MAYBERRY PHASE 2

PUD DEVELOPMENT PLAN AND PRELIMINARY PLAN

Mayberry Phase 2
El Paso County
PUD Development Plan & Preliminary Plan
DESIGN STANDARDS

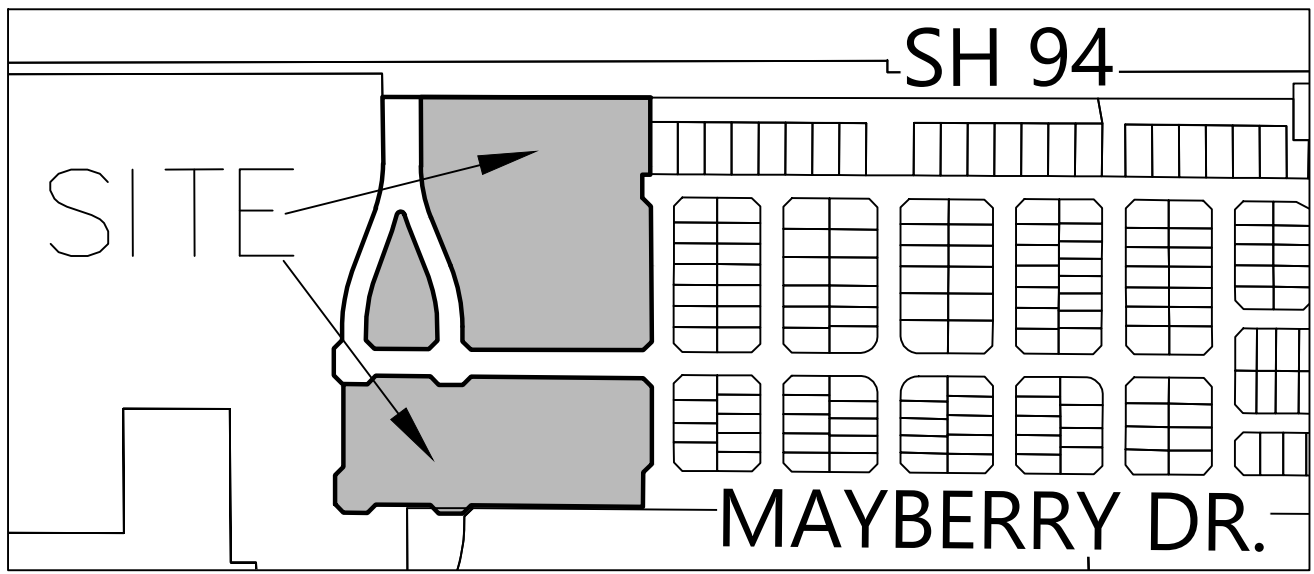
add a note here that no ground-level encroachments are permitted in the easements, including but not limited to window wells, awnings, chimneys, etc.

According to the PUD special standards modification request, you are also requesting LDC Secs. 6.2.5, Table 5-4 modification, and Sec. 6.3.3.C.3.e modification. Please include these in the table on the plan set.

Please note this table needs to include every individual modification requested, listed by specific LDC/ECM section.

Delete as a greater radii than the minimum is provided.
